**SERVICE BULLETIN 145**

**SUBJECT:** Glasair III Rod-End Bearings (Part Number 170-0110-003)

**APPLICABILITY:** 170-0110-003 rod-end bearings shipped to Glasair III builders before 6/30/96 (through kit serial number 3308)

**ROD-END BEARING MODIFICATION**

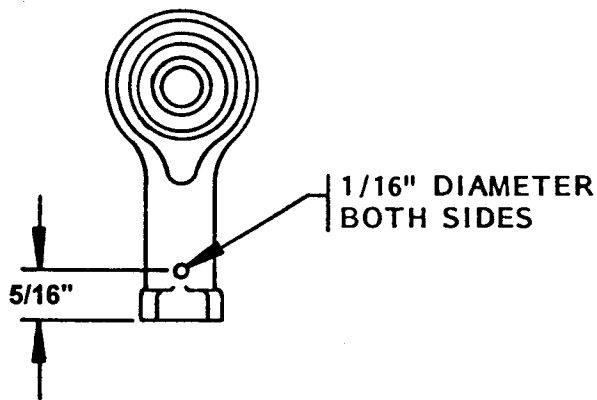
**DISCUSSION:** The affected rod-end bearing, which is used in the Glasair III cowl flap installation, may lack the two small inspection holes that are necessary to determine if the rod-end is threaded a sufficient distance onto its actuator rod.

Any rod-end bearing without inspection holes must be modified to permit verification of adequate threading onto the control actuator rod. Using a 1/16" bit, drill holes through both sides of the rod end bearing 5/16" from the threaded end of the bearing, as shown.
